TITLE : FUEL SYSTEM INTEGRITY

Test No. : 86-251  
Test Date : 06/25/96

Vehicle : Model TRACKER 4door Body Style VAN Year 1996  
Number 2CNBJ1365T6954035 Make Production

Permanent Countermeasure for Fuel Tank Gusset of YH9(YE7 Series), Y4T(YOE Series) (by Making Engineering Change)

(Fig.1) S 212081

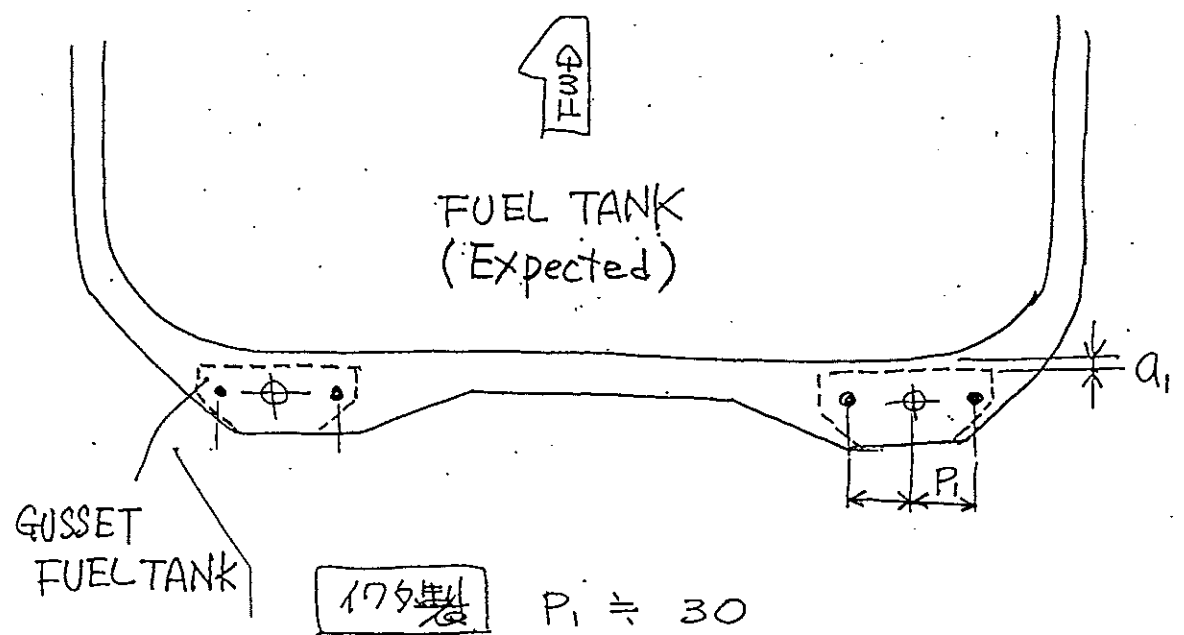
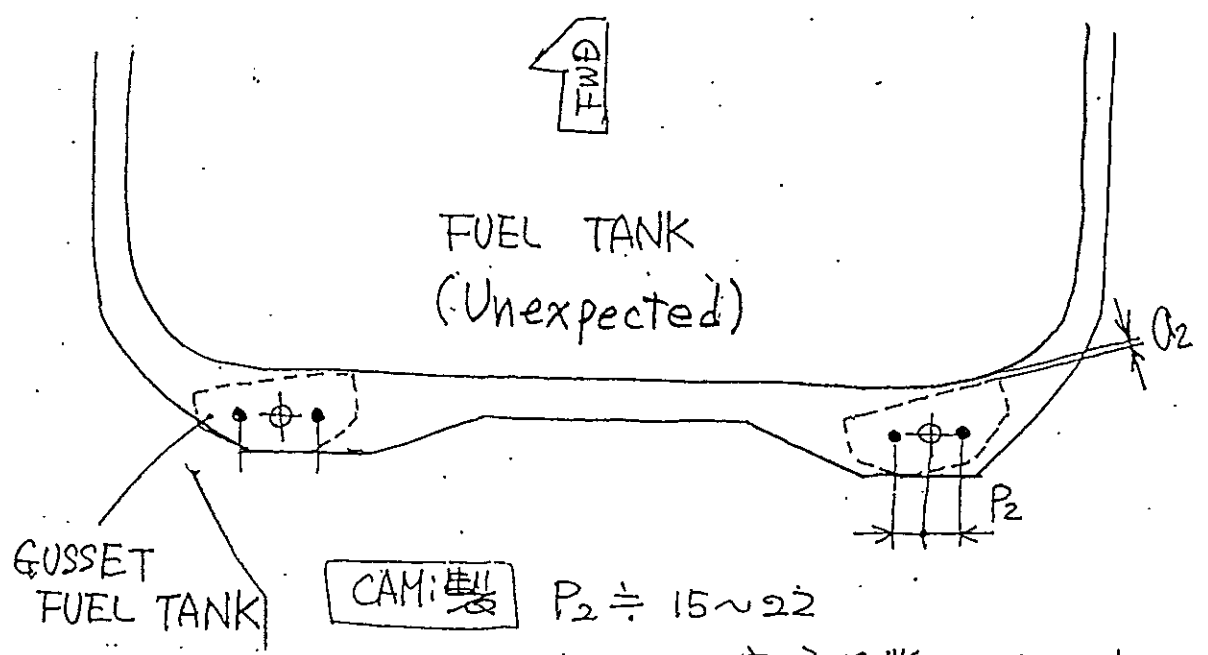
- a) Change in the shape of the tank mounting bracket starting with '96MY. (Fig.1)
- b) Variation in the installation position of the tank reinforcement gusset. (Fig.2)
- c) Variation in the spot welding pitch of the tank reinforcement gusset. (Fig.2)

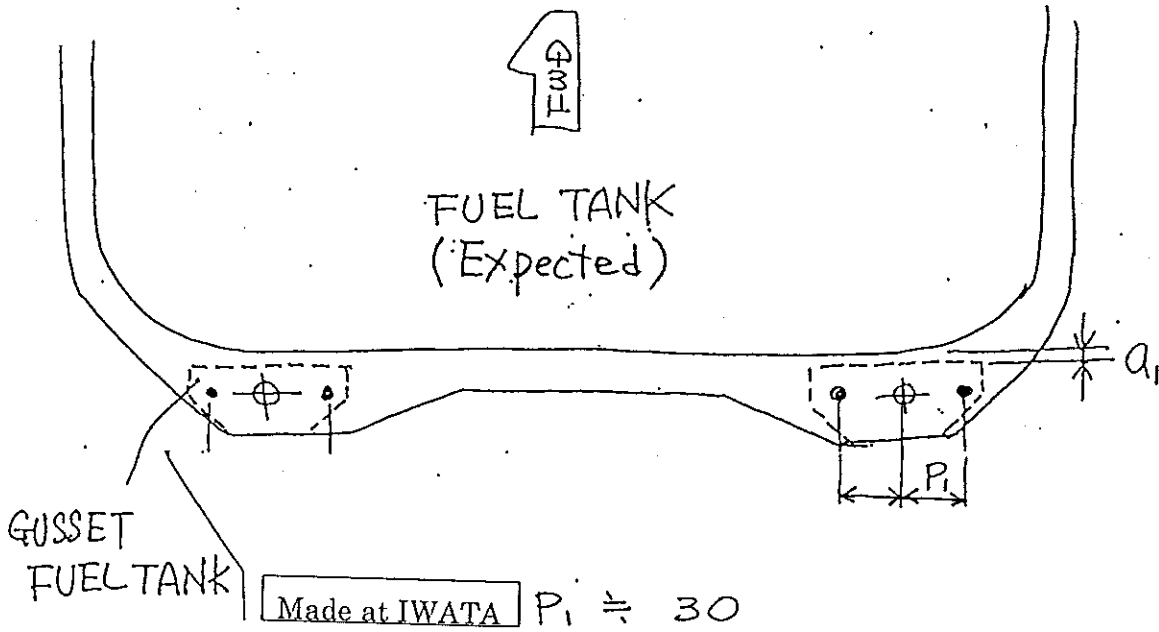
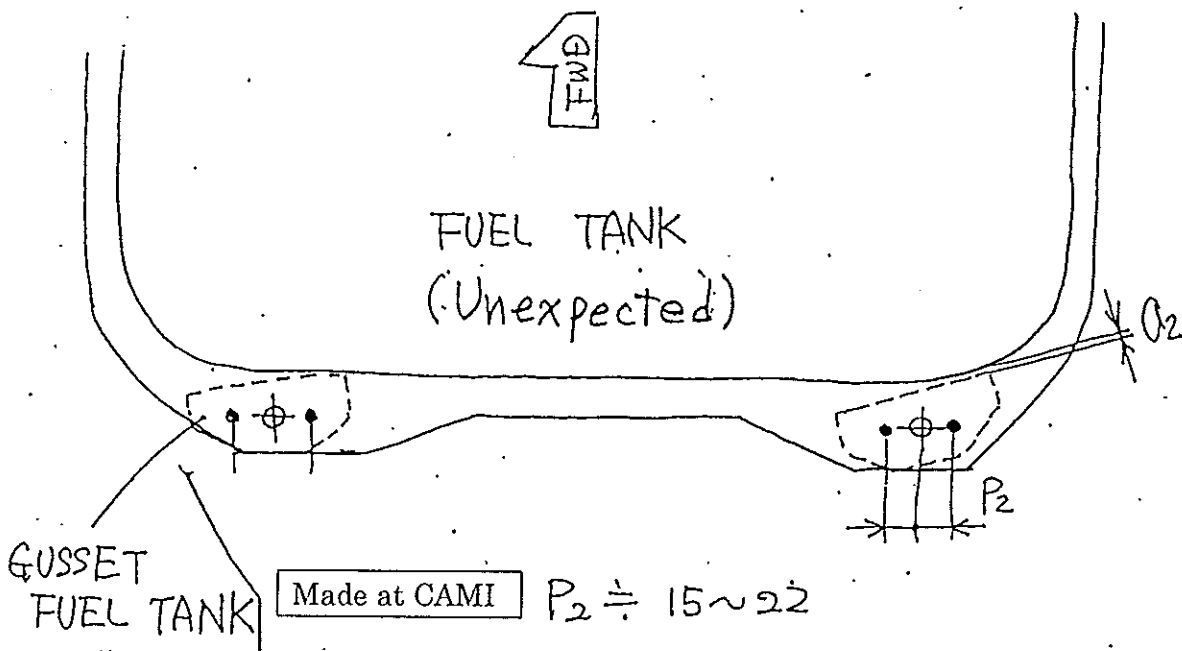
The pitch is stable as welding is done by a robot.

$a_1$ ; Inclination of the gusset is small (measured data)

There is much variation as welding is done manually and the pitch is narrow.

$a_2$ ; Inclination of the gusset is large (measured data)
